PROFILE OF LINDEN COURT.

OFFICE OF CITY ENGINEER
Sept. 1912
360-87
R.N. Clark

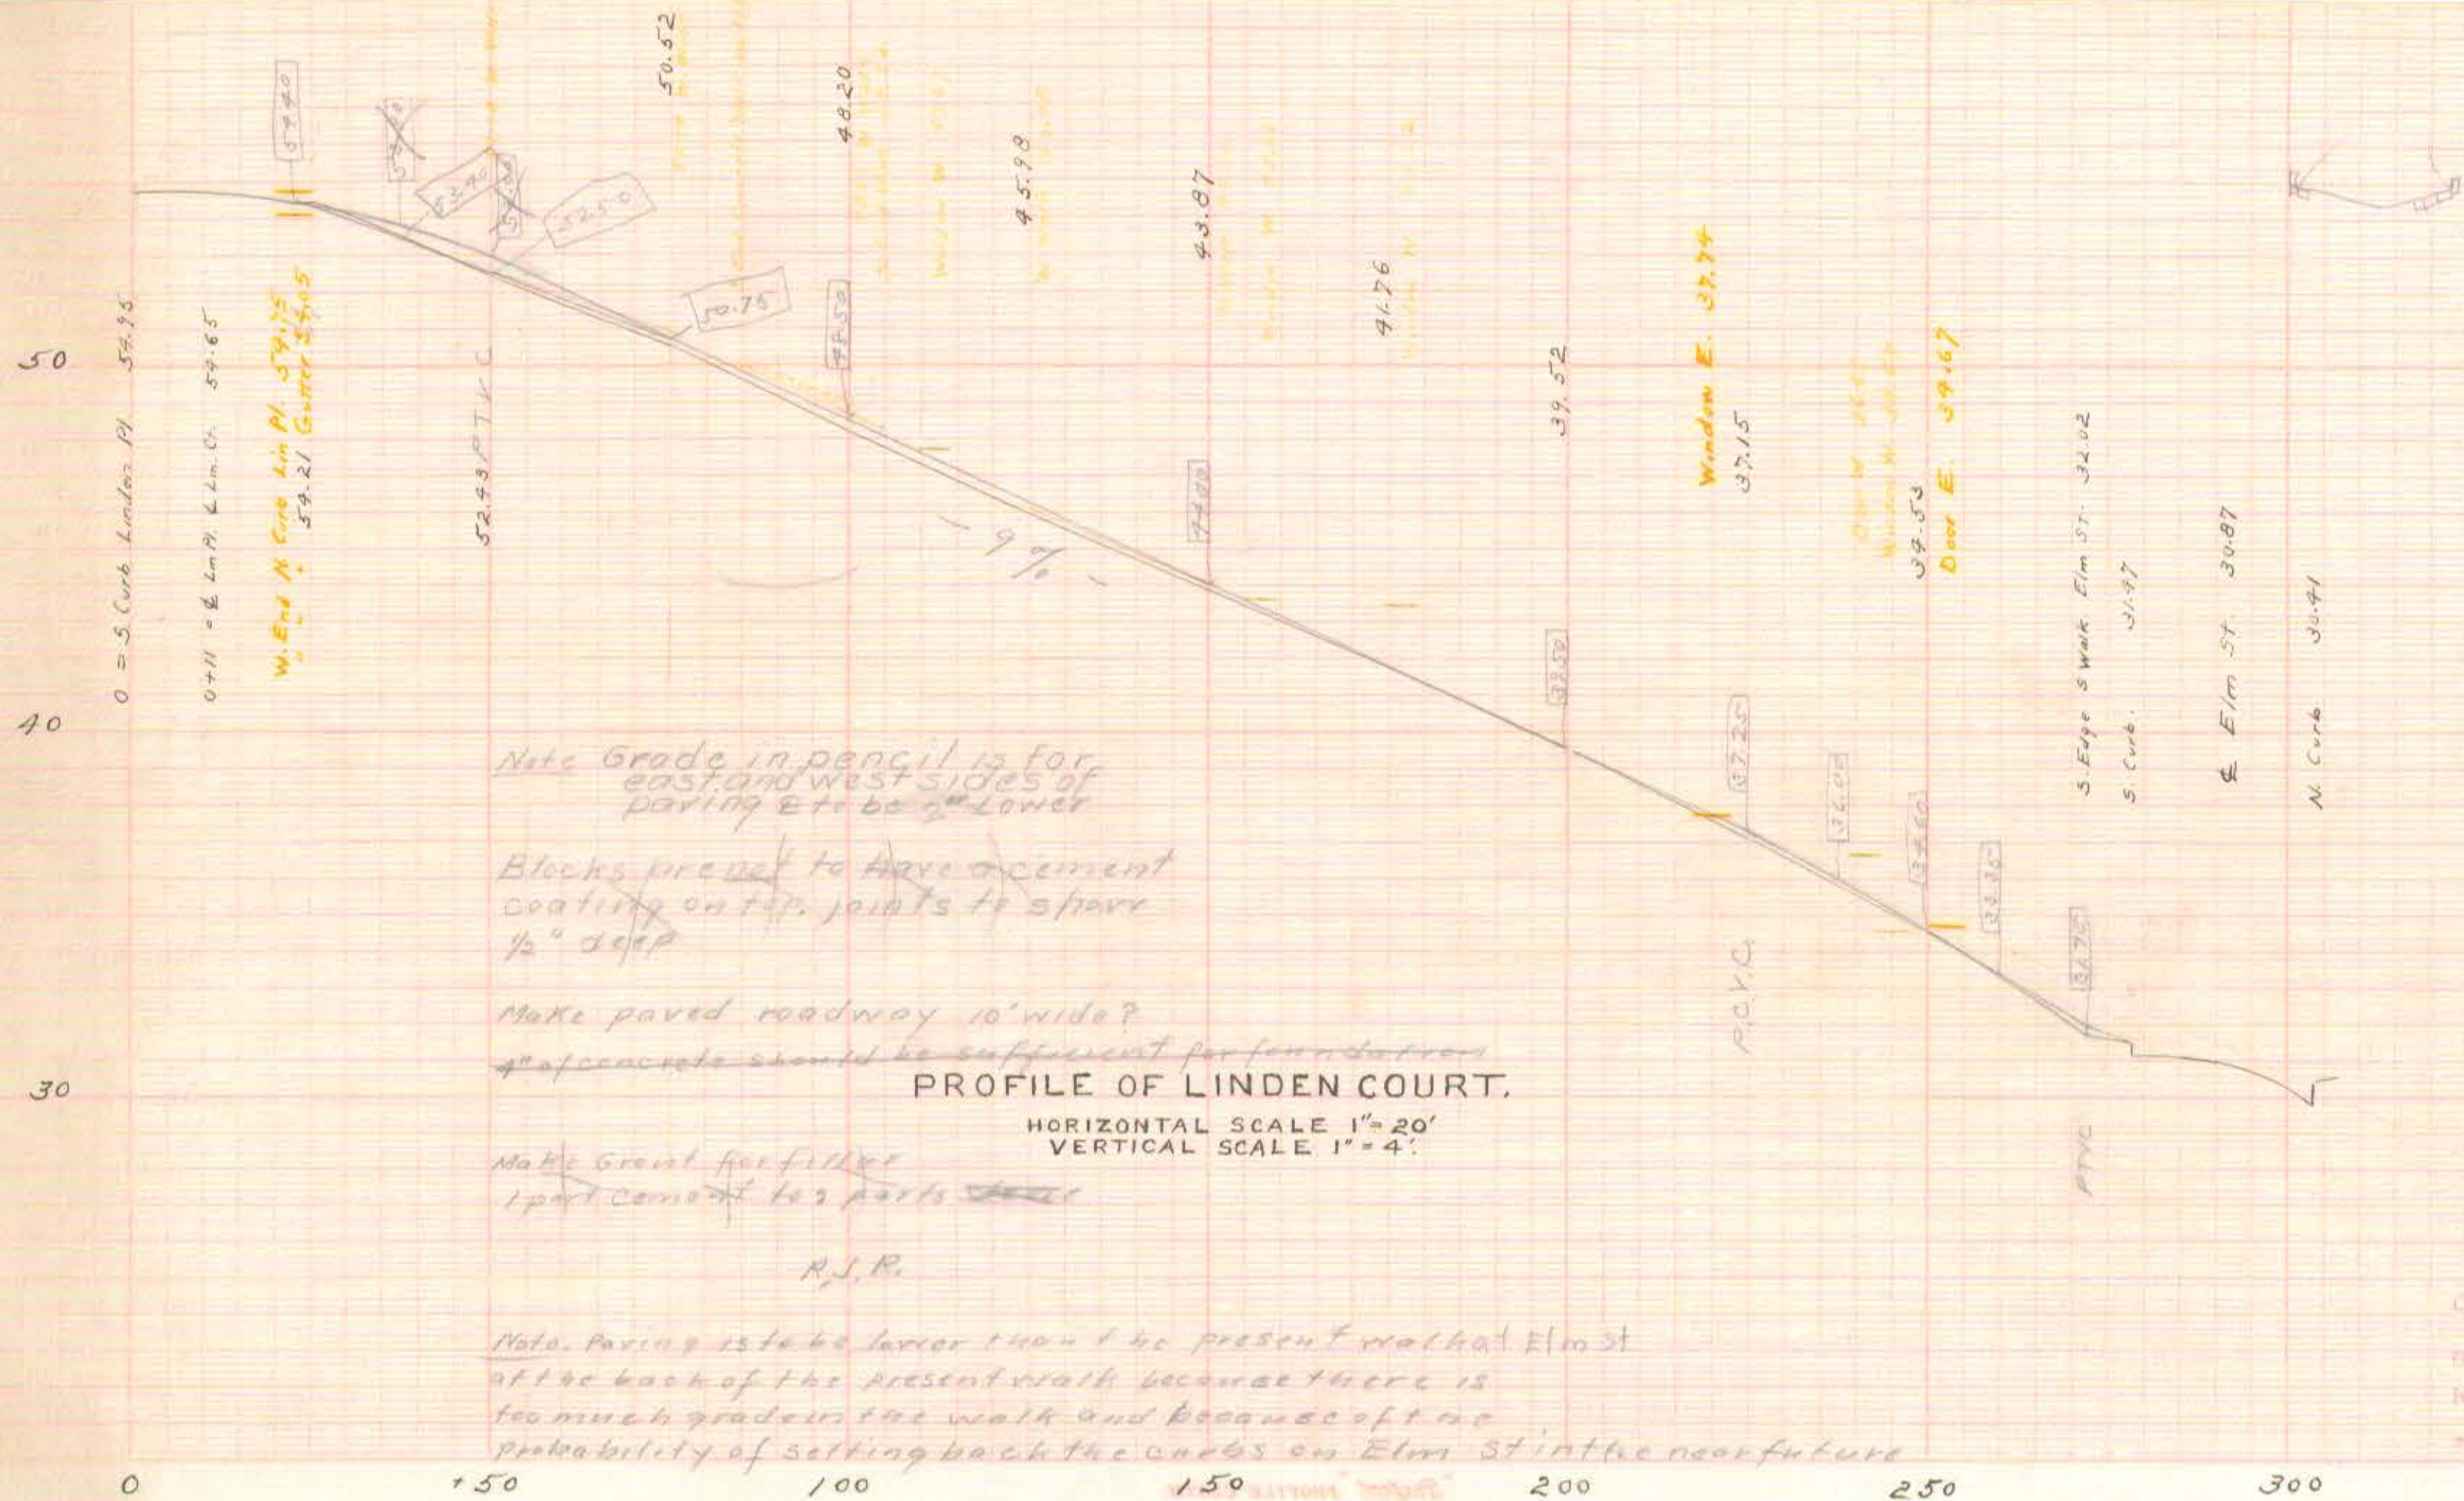
Note Grade in pencil is for east and west sides of paving etc to be 2" lower

Blocks prepared to have a cement coating on top. joints to spave 1/2" deep

Make paved roadway 10' wide?

4" of concrete should be sufficient for foundations

Make Gravel for filler
1 part cement to 3 parts ~~stone~~

Note. Paving is to be lower than the present walk at Elm St at the back of the present walk because there is too much grade in the walk and because of the probability of setting back the curbs on Elm St in the near future
